# **Addendum to Appendix D**

## **Technical Alignment Report**

*Prepared by*  
Alaska Department of Transportation and Public Facilities  
6860 Glacier Highway  
Juneau, Alaska 99801-7999

This addendum outlines changes to the design criteria, updates the alignment discussion where changes have occurred, provides updated bridge summaries, provides updated plan and profile sheets where changes have occurred, updates ferry terminal layouts and cost estimates, updates the Engineer's Estimate, and provides an errata sheet for the original technical report.

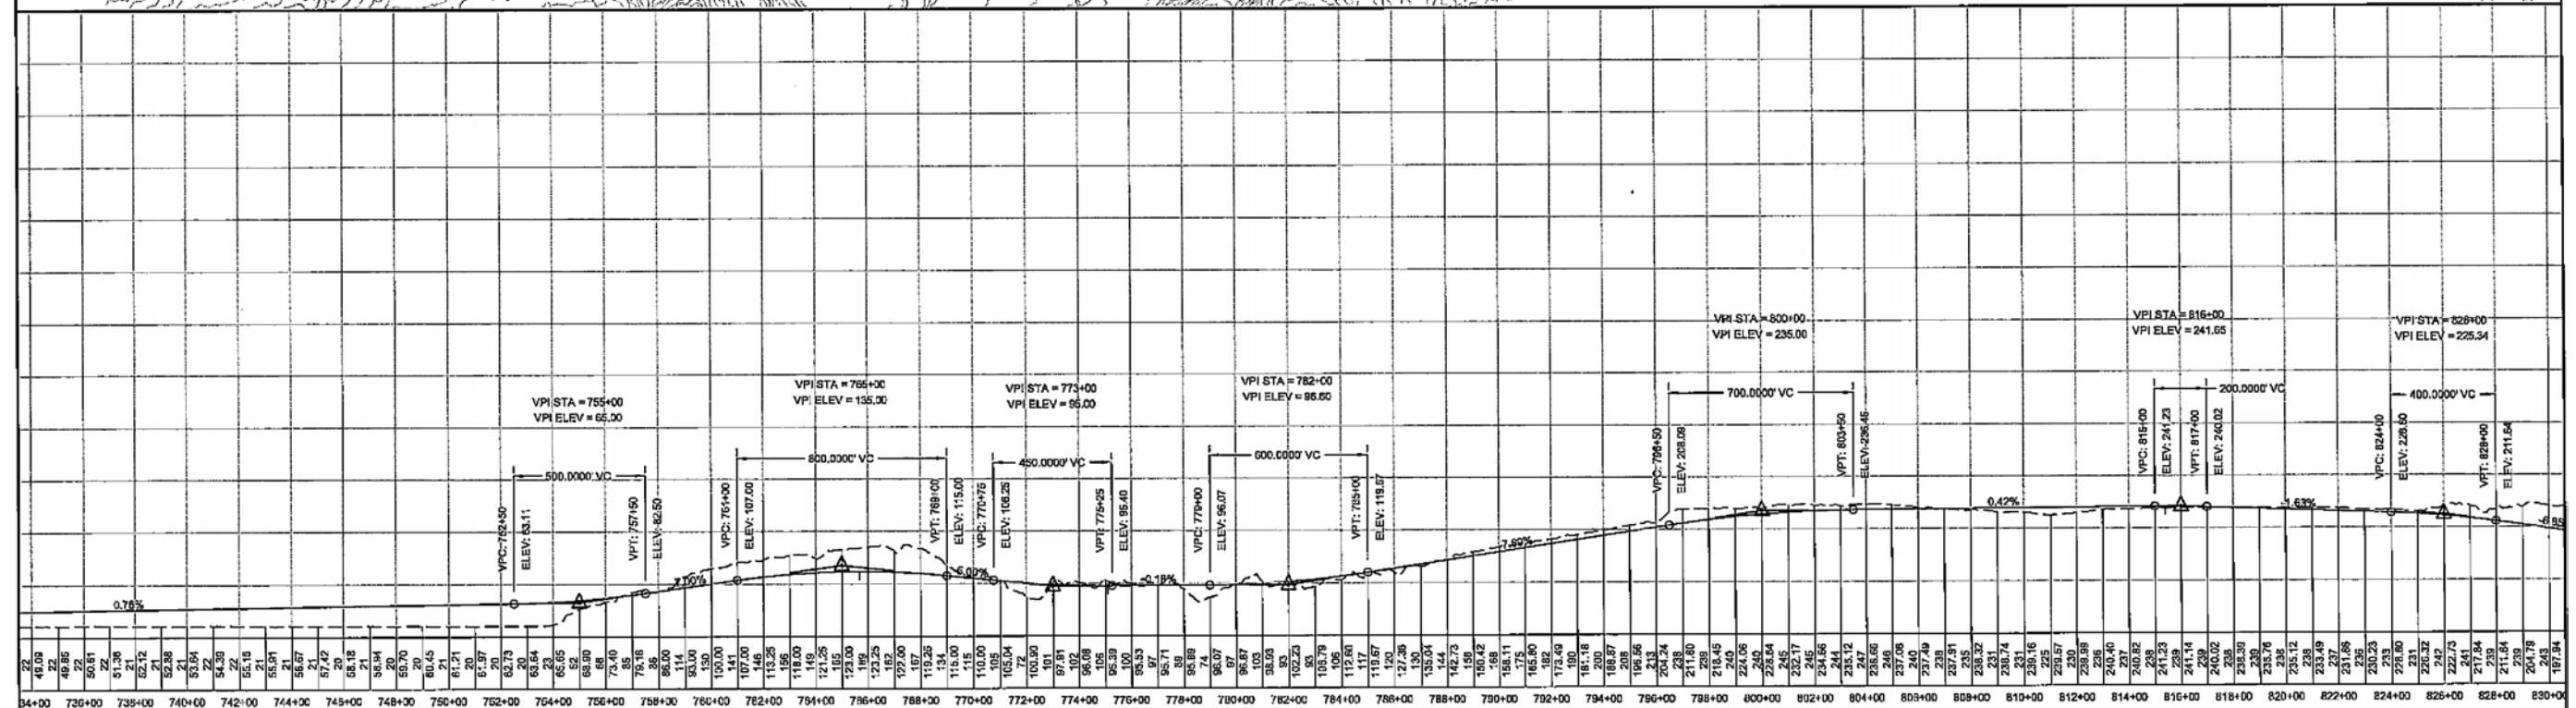
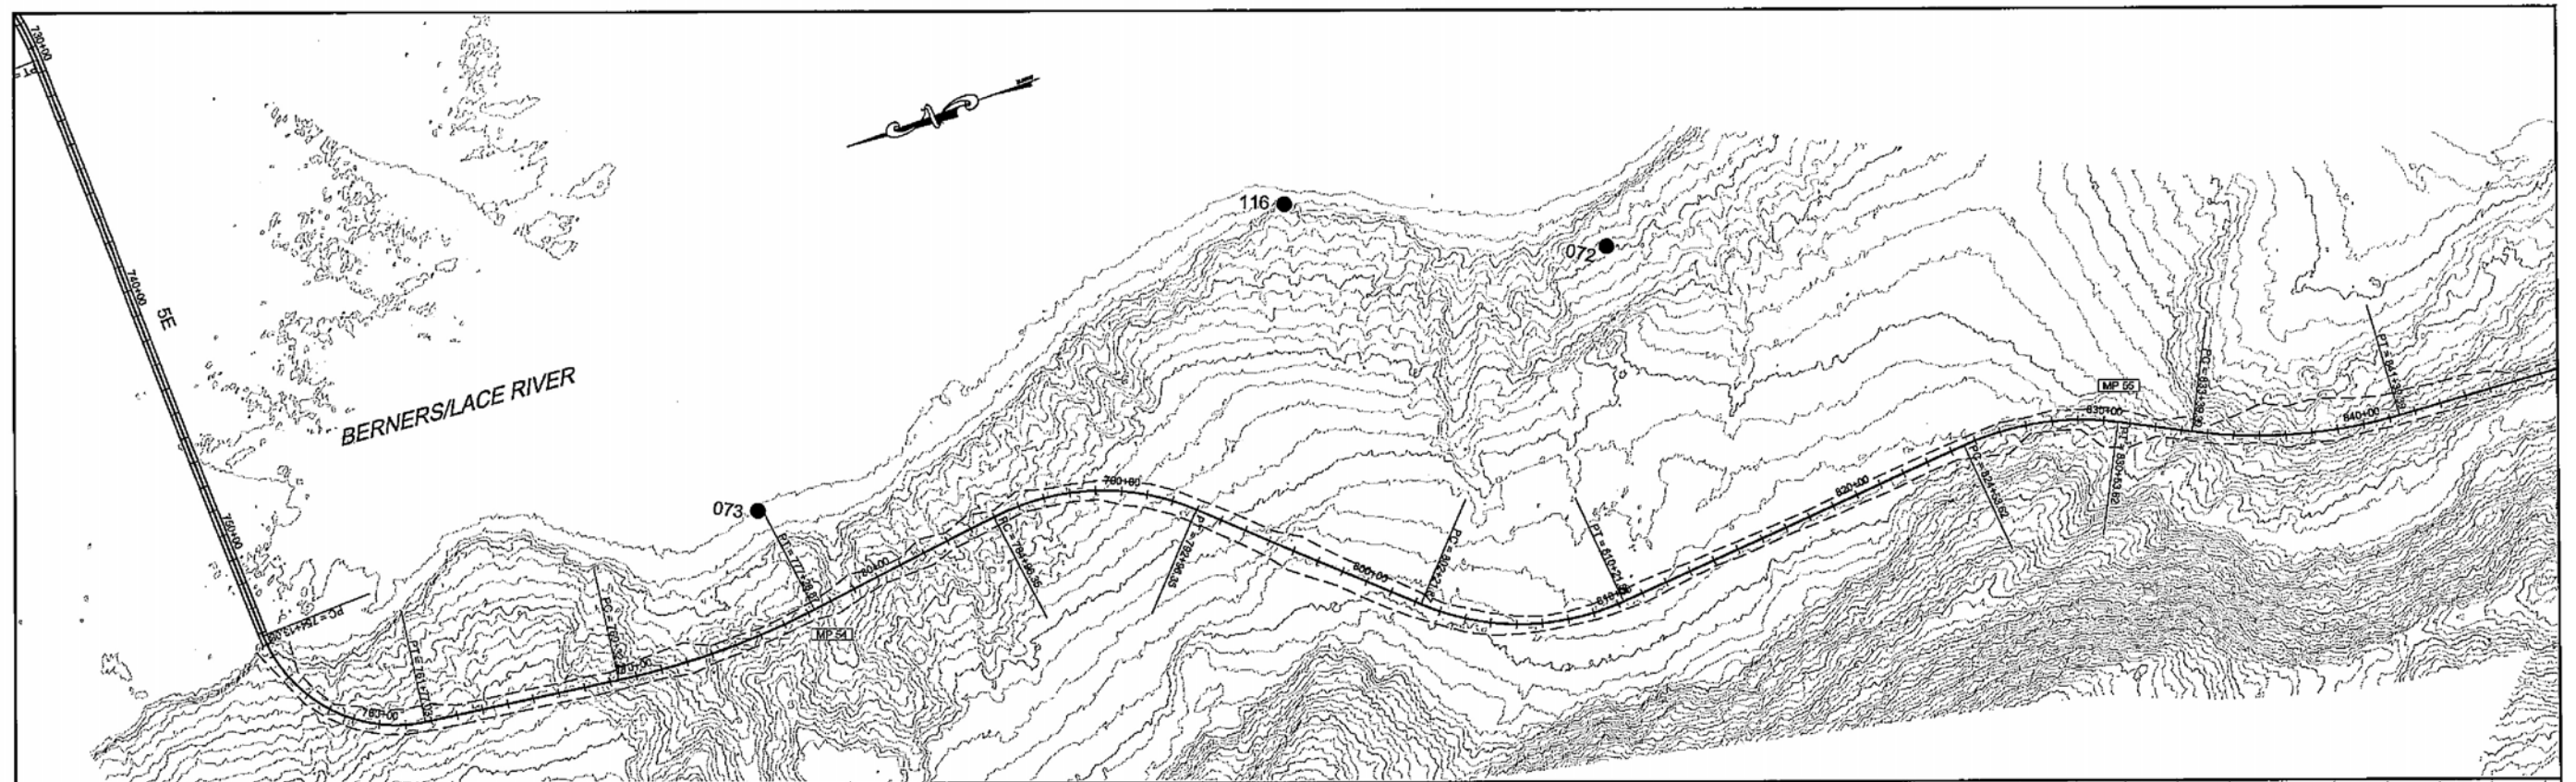
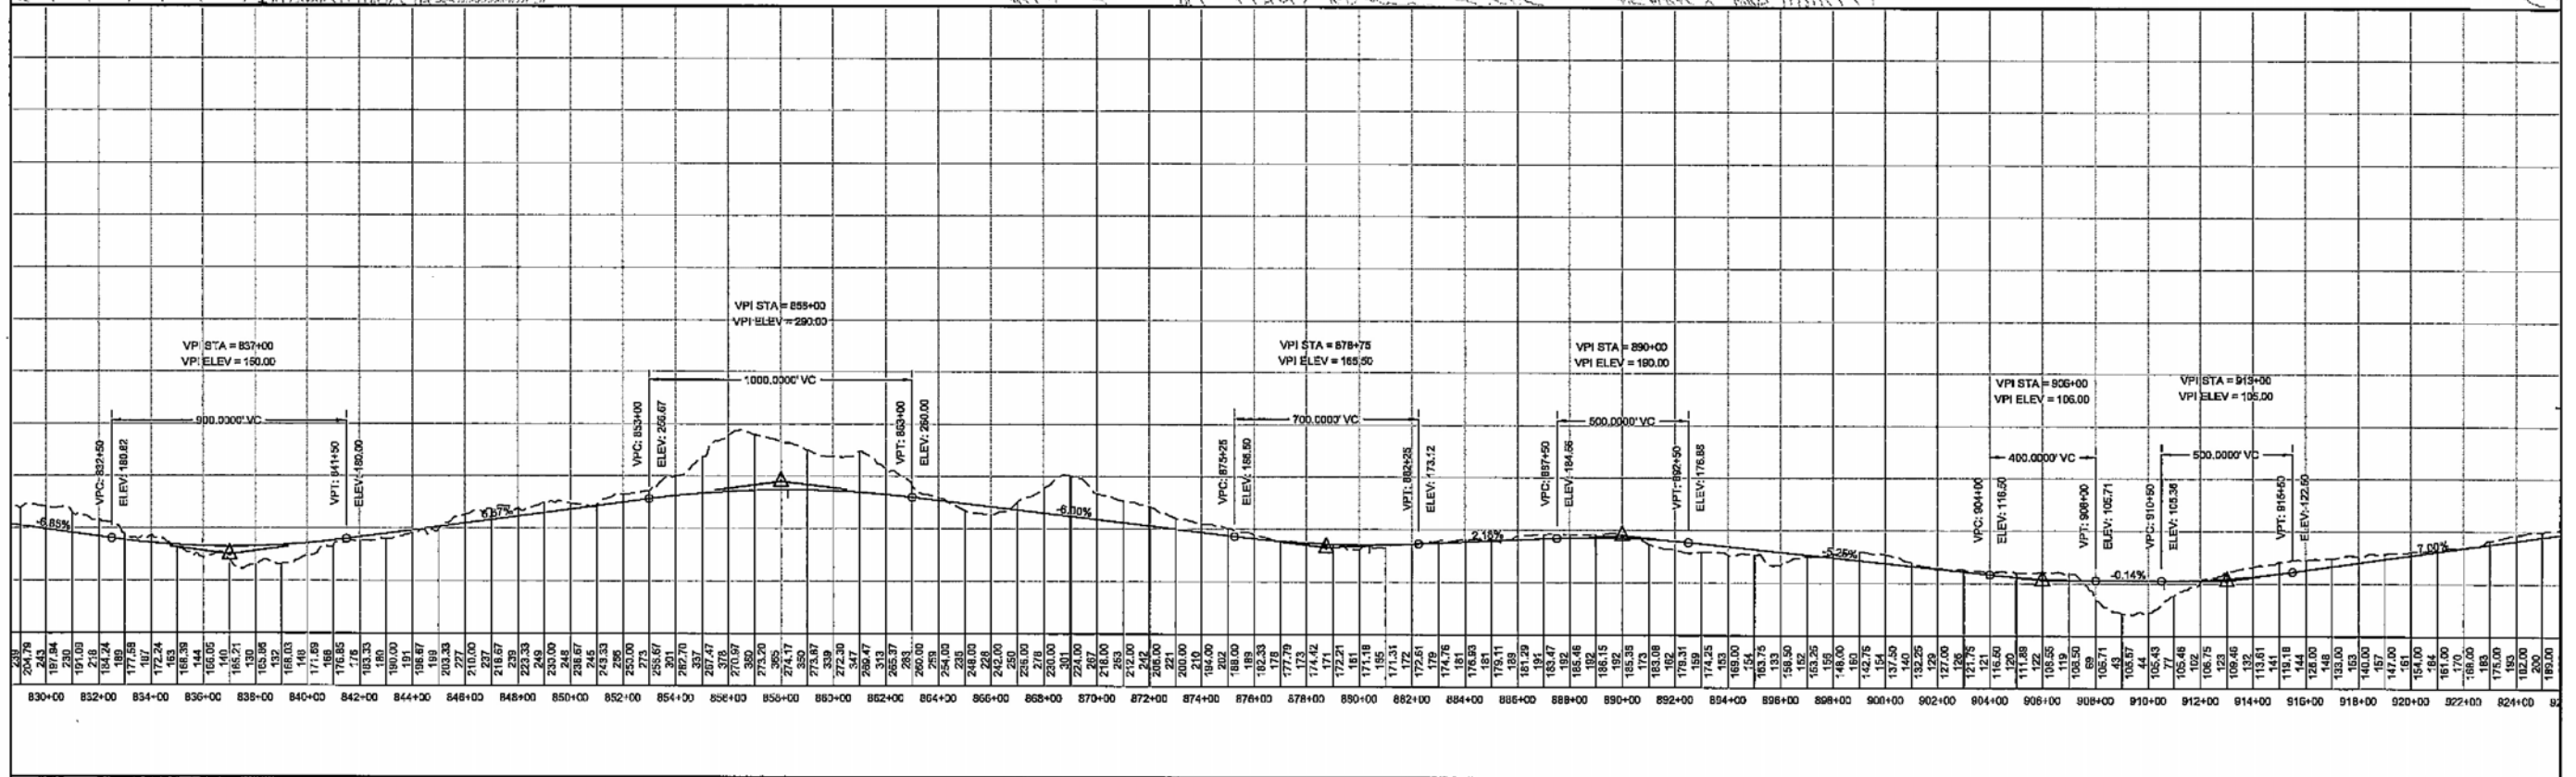
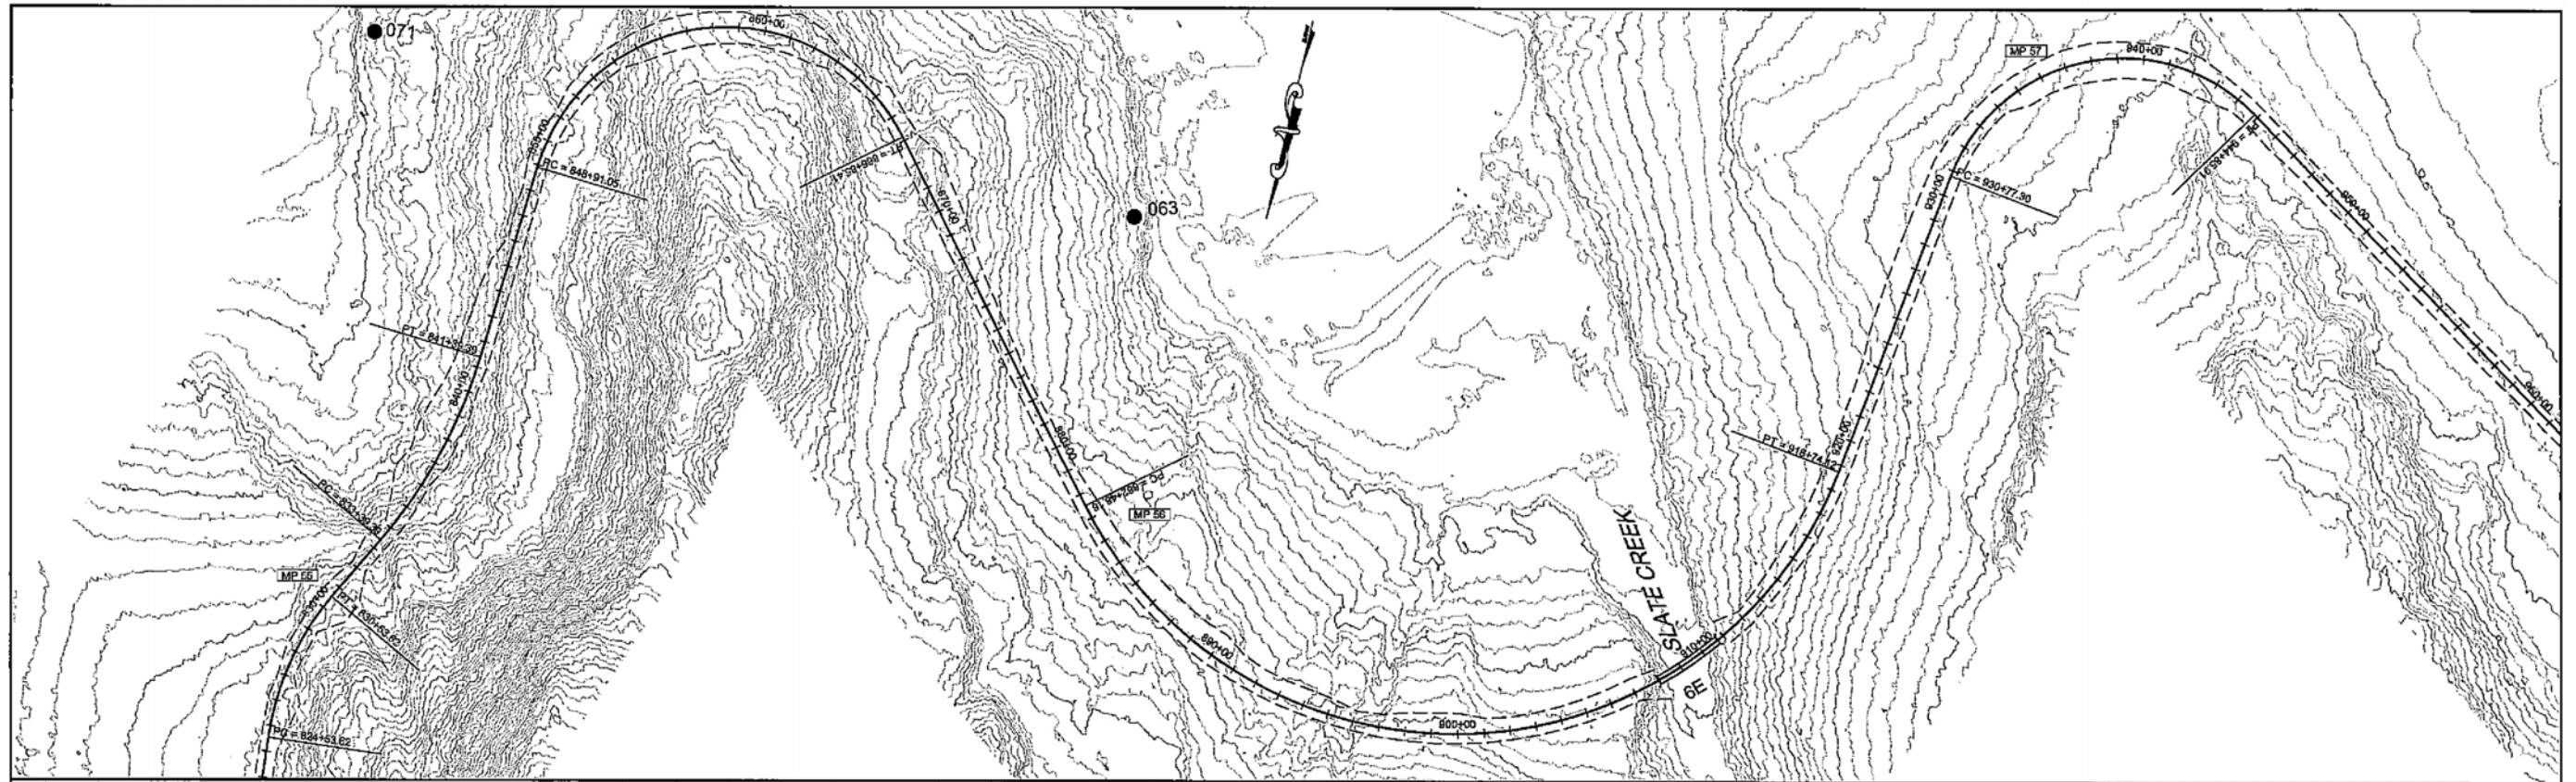
**Station 561+00 (MP 49.9) to Station 754+50 (MP 53.6) - Berners Bay Crossing** – This segment was lengthened to 3.7 miles as a result of major alignment revisions, the first of which was outlined in the preceding segment description. This revision moved the alignment off of steep slopes onto relatively flat, timbered uplands.

This realignment also provided a more desirable crossing over the anadromous fish stream here by reducing the skew of the bridge in relation to the stream channel. The bridge length remains at 130 feet.

The crossings over the Antler/Gilkey River and the Berners/Lace River were revised to address resource agency concerns. These revisions increased the bridge lengths to 2,600 feet and 2,750 feet, respectively.

Two new bridges were added to span high use bear trails. The first bridge, located at Station 669+08, crosses an Anter/Gilkey River overflow channel and associated bear trail, and has a preliminary length of 146 feet. The second bridge is a 100-foot-long structure that crosses a bear trail near Station 692+50.

Revised Plan and Profile Sheets for this segment (Sheets 8-9) are included in Attachment A.

**Station 754+50 (MP 53.6) to Station 1390+00 (MP 65.6) - Berners Bay Crossing to Independence Lake** – This 12.0-mile segment was revised at multiple points to minimize or eliminate impacts to wetlands along the segment. The Revised Plan and Profile Sheets (Sheets 9-13) are included in Attachment A.
